**ENVIRONMENTAL IMPACT REPORT
ADDENDUM FOR THE PROPOSED
TRANS BAY CABLE PROJECT**

**City of Pittsburg
65 Civic Avenue
Pittsburg, CA 94565**

URS Corporation

December 2006

Bundle Configuration*

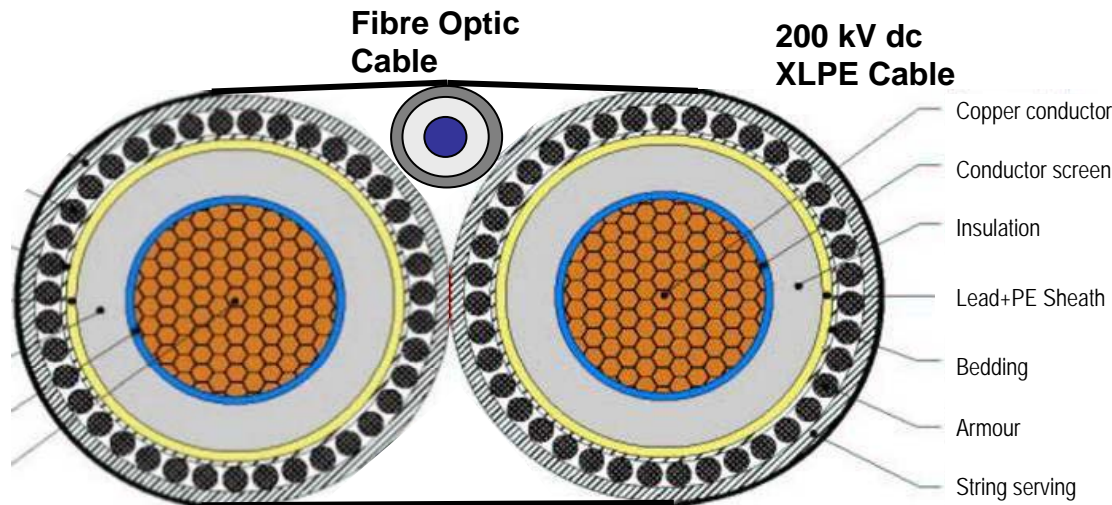
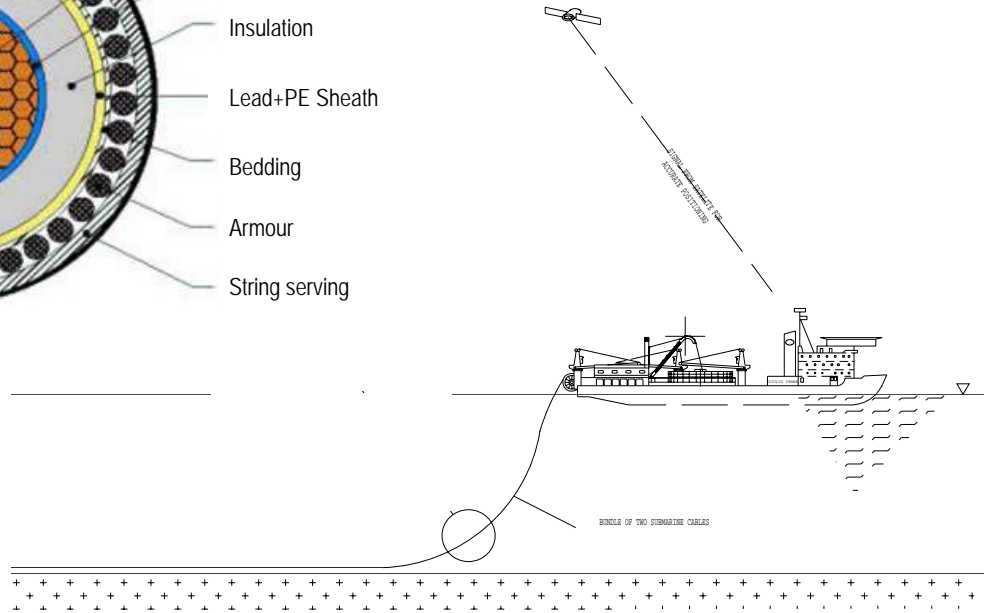
In order to accommodate the HVDC PLUS converter station design addressed in this EIR Addendum, the design of the submarine HVDC cable system bundle between Pittsburg and San Francisco has been modified. The carrying capacity of the submarine cable is still 400 MW as evaluated in the Draft and Final EIRs, however, the planned cable design now consists of two, 200 kV cables (one positive, one negative) and a fiber optic communication cable (refer to Figure 2.4-1). The HVDC submarine cable system design addressed in the Draft and Final EIRs consisted of one 400 kV cable, one 12 kV return (ground) line, and a fiber optic cable. The HVDC submarine cable system would still be approximately 10 inches in diameter and would be bundled prior to burial at a target depth of 3 to 6 feet below the bottom of the Bay using a hydroplow deployed from a cable laying vessel as described in the Draft and Final EIRs. The submarine cable route and construction methods are as evaluated in the Draft and Final EIRs. The operational characteristics (e.g., electric and magnetic fields and heat) would be essentially the same as those described in the Draft and Final EIRs.

TRANS BAY CABLE PROJECT EIR
 Figure 2.6-2. PITTSBURG CONVERTER STATION PLAN VIEW (WEST TENTH STREET HVDC PLUS)

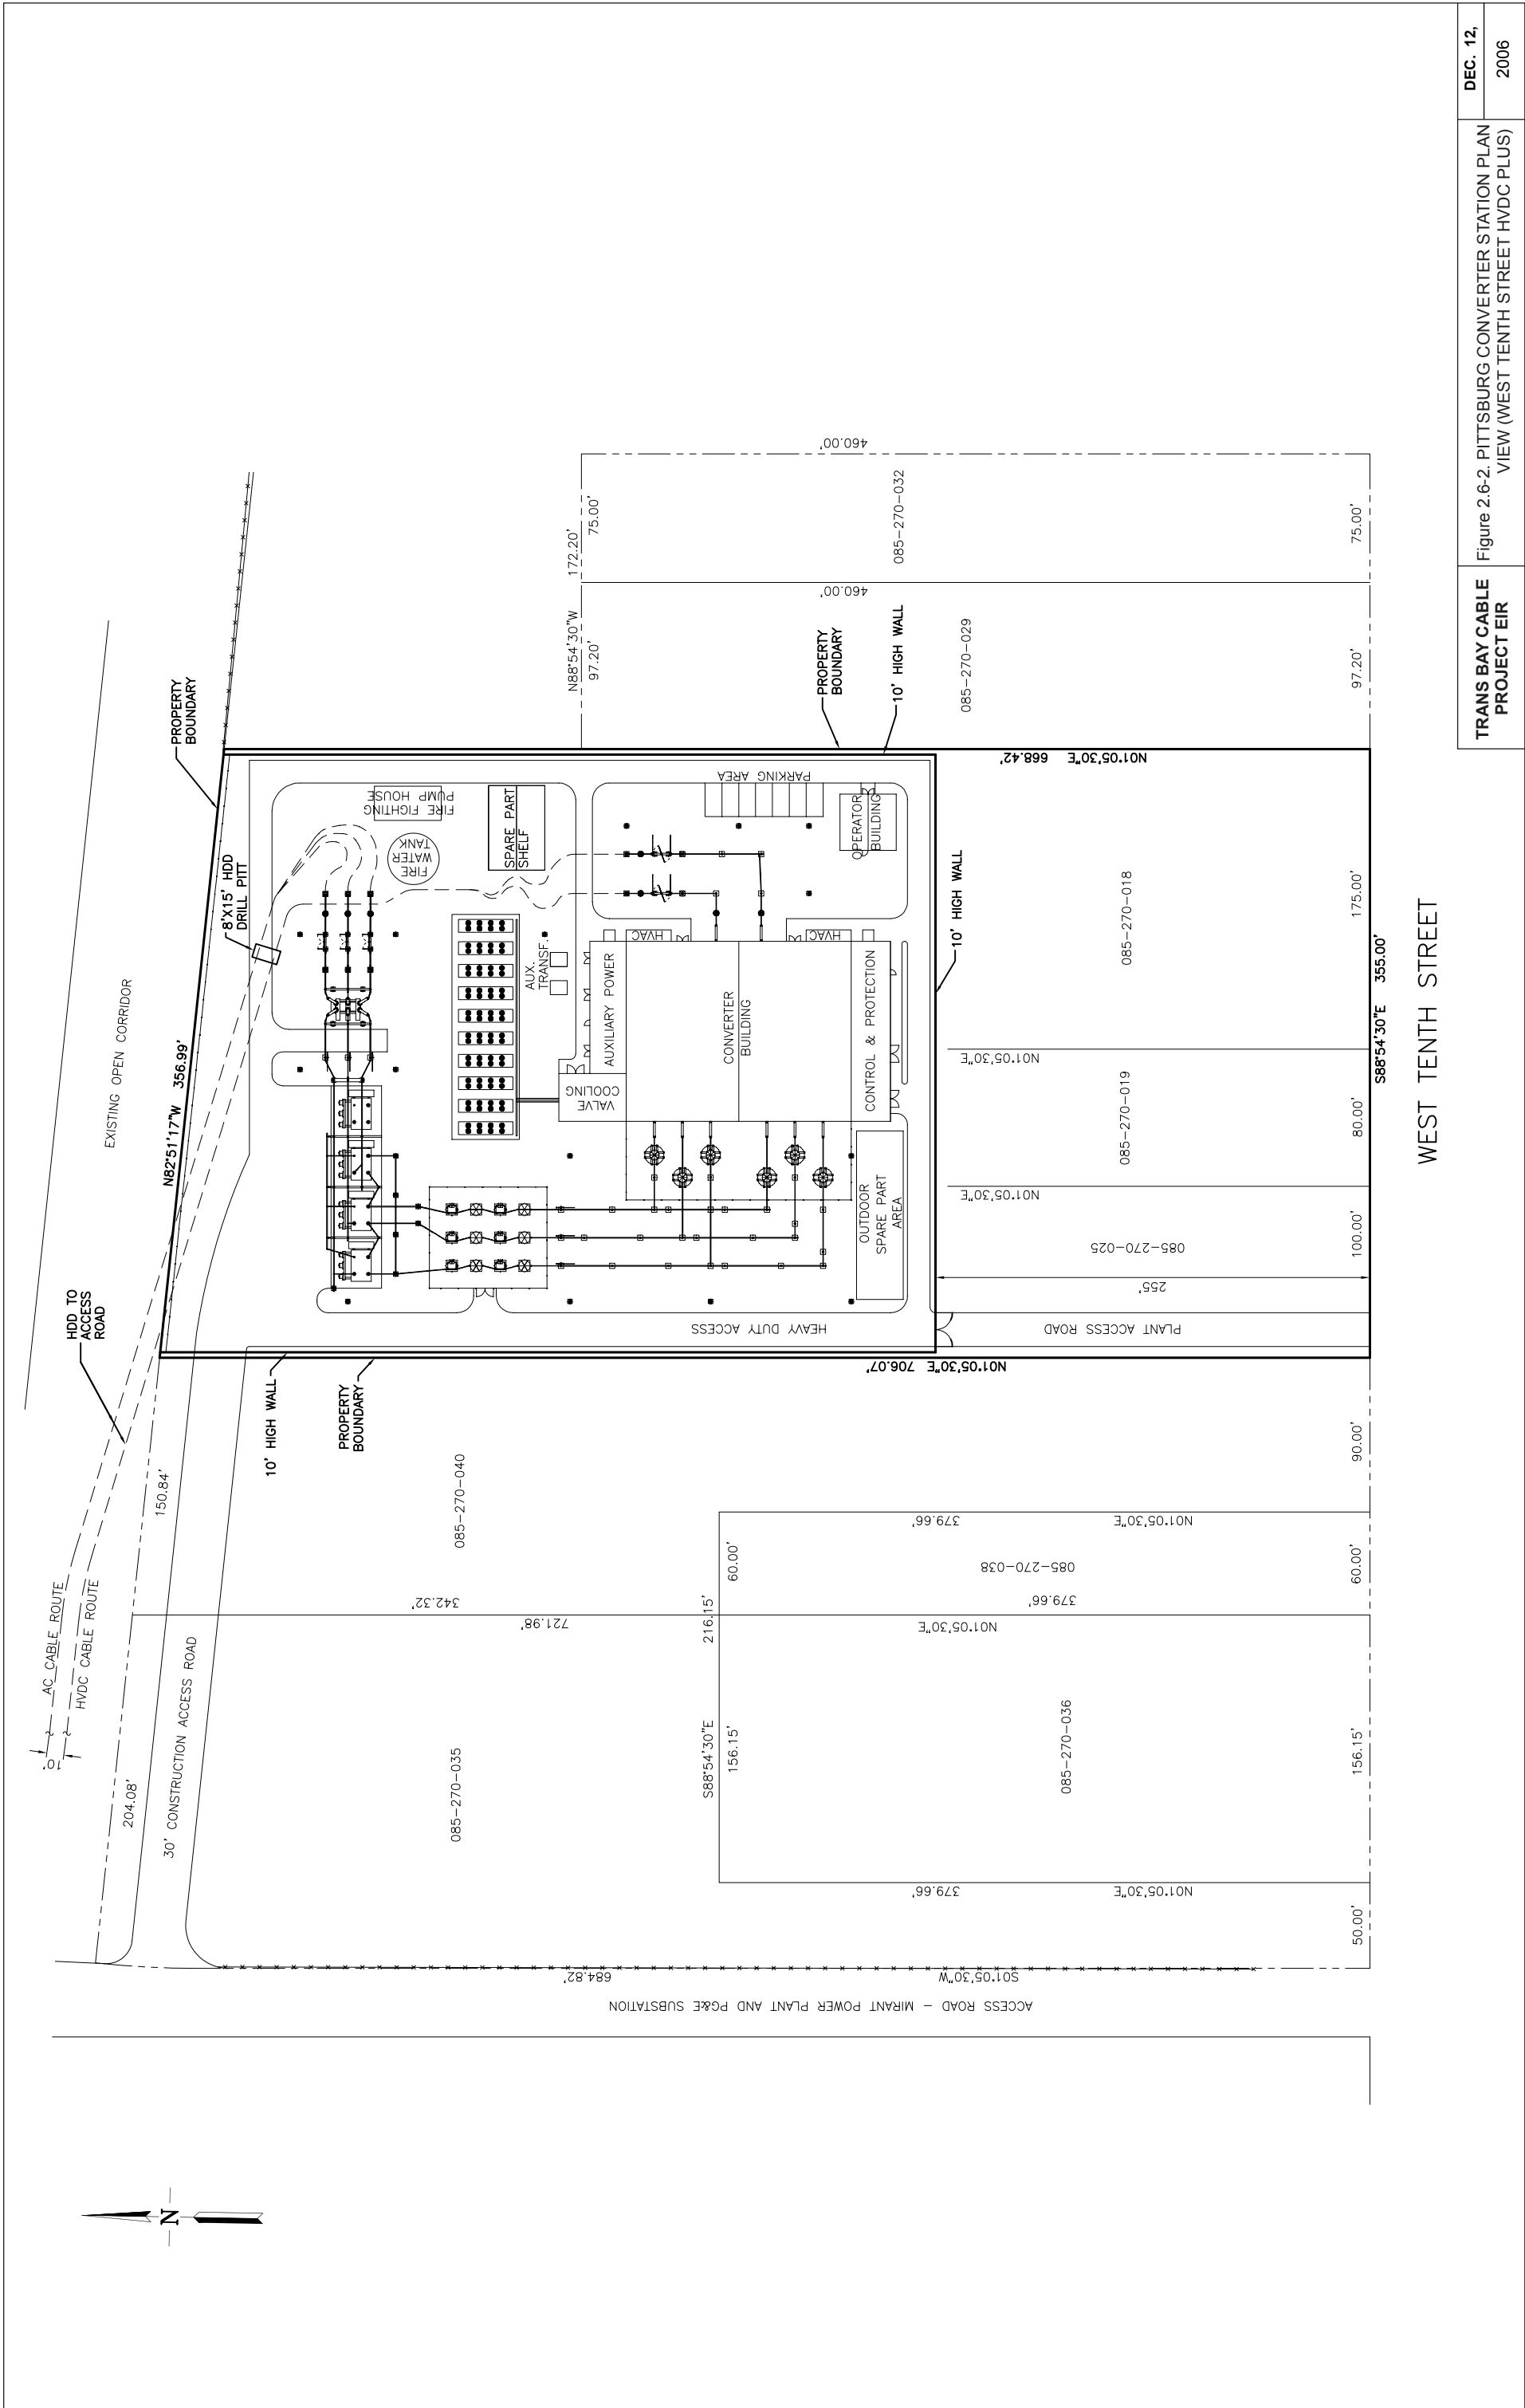
The Pittsburg West Tenth Street Alternative HVDC PLUS site and layout are shown on Figures 2.6-1 and 2.6-2, respectively. A temporary construction access road (30 feet wide) would be constructed along the northerly portion of the previously assessed Pittsburg West Tenth Street Alternative 1 site (refer to Figures 2.6-1 and 2.6-2). Figure 2.6-1 also shows the onshore DC and AC cable routings which are essentially the same as those evaluated in the Draft and Final EIRs. An elevation view of the HVDC PLUS layout at this site is shown on Figure 2.6-3. A photosimulation with landscaping in the buffer area is shown on Figure 2.6-4, and a photosimulation without landscaping is shown on Figure 2.6-5.

Site access during the operational phase for the Pittsburg West Tenth Street Alternative 1 site, as modified, would be via West Tenth Street (refer to Figures 2.6-1 and 2.6-2 of this Addendum) similar to the previously considered site except that the road would be situated further to the east for the HVDC PLUS site. Construction access to the Pittsburg West Tenth Street Alternative 1 site as evaluated in the Draft and Final EIRs involved use of the Mirant Pittsburg Power Plant access road as does this EIR Addendum although an extension would need to be constructed to the east to the modified site. None of these Project modifications would result in any new potentially significant traffic related impacts.
